GE Energy

MFN 07-009

Docket No. 52-010

Subject: **Response to Portion of NRC Request for Additional Information
Letters No. 79 and 85 – Containment - RAI Numbers 6.2-125 and
6.2-150, and Revised Responses to RAI Numbers 6.2-111 and 6.2-129**

Figure 6.2-125-1

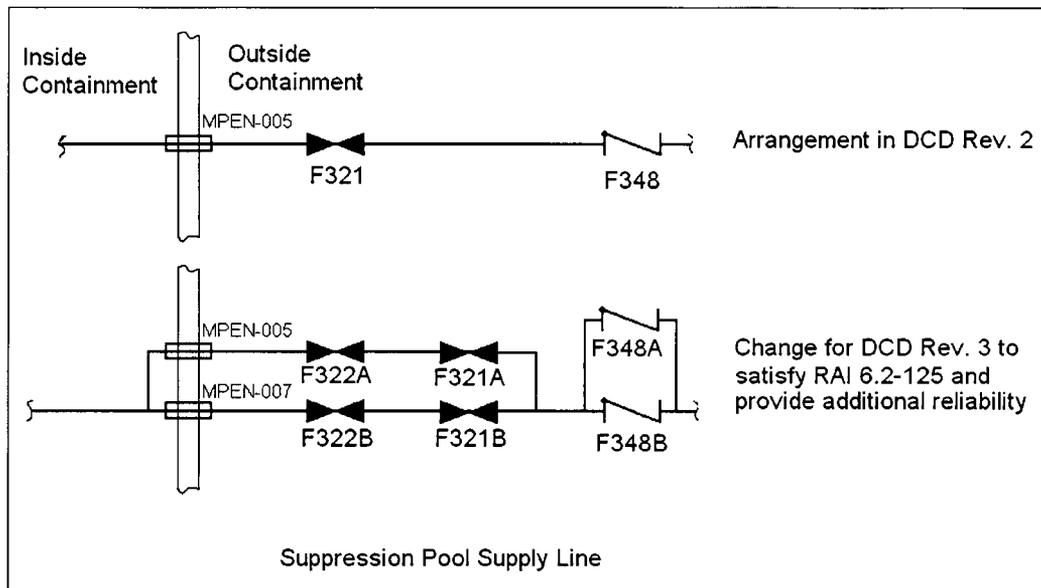
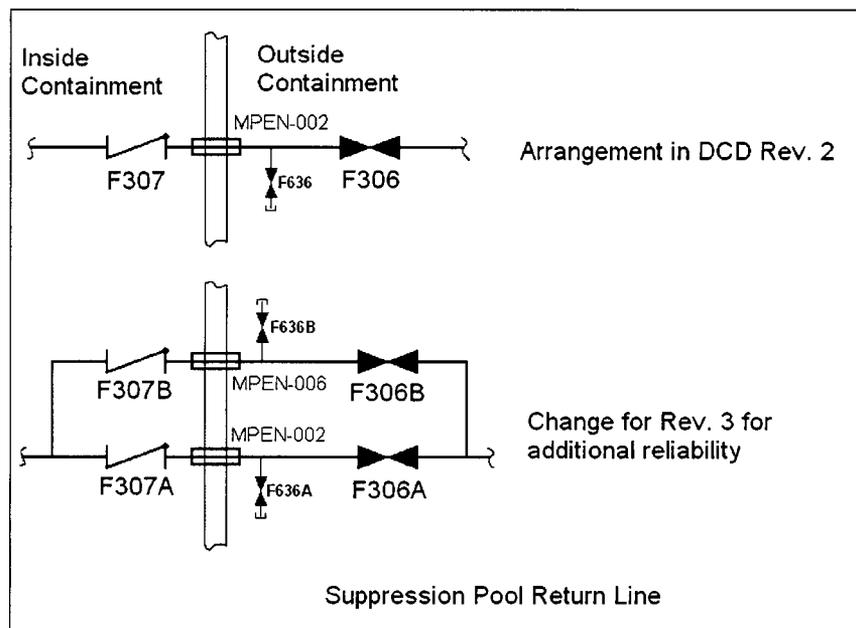
Further, the design takes credit for a closed system outside containment as the second containment isolation barrier. As detailed in RAI 6.2-102, there are a number of guidelines in SRP 6.2.4, Rev. 2, RG 1.141, and ANS-56.2/ANSI N271-1976 which govern the design of a closed system outside containment when used as a containment isolation barrier. Address these guidelines in the DCD.

The Fuel and Auxiliary Pools Cooling System (FAPCS) is no longer being credited as a closed system outside containment, and as a result a second containment isolation valve has been added to the suppression pool supply line in series with the existing valve. Both valves are located outside the containment and as close to the penetration as possible. The second valve is not located inside containment because it could potentially be submerged by water during a severe accident. This arrangement is acceptable to meet the requirements of 10 CFR 50 Appendix A, GDC 56 and the additional guidelines for acceptable alternate containment isolation provisions for this class of line described in NUREG-0800, Standard Review Plan (SRP) 6.2.4, Section II.d.

In order to improve reliability for the Suppression Pool Cooling and Low Pressure Coolant Injection functions, and to address uncertainty in the Probabilistic Risk Analysis (PRA) safety goals, a parallel redundant flow path through containment has been created for the suppression pool supply and return penetrations. As a result, in addition to adding a second valve in series, there is now a second containment penetration (also containing two outboard containment isolation valves). Likewise, the suppression pool return flow path will now contain an additional penetration with a redundant pneumatic-operated outboard isolation valve and an inboard check valve. The supply and return lines each branch upstream of the containment penetration, and return to a single flow path downstream of the second containment isolation valve. Figures 6.2-125-1 and 6.2-125-2 illustrate this change.
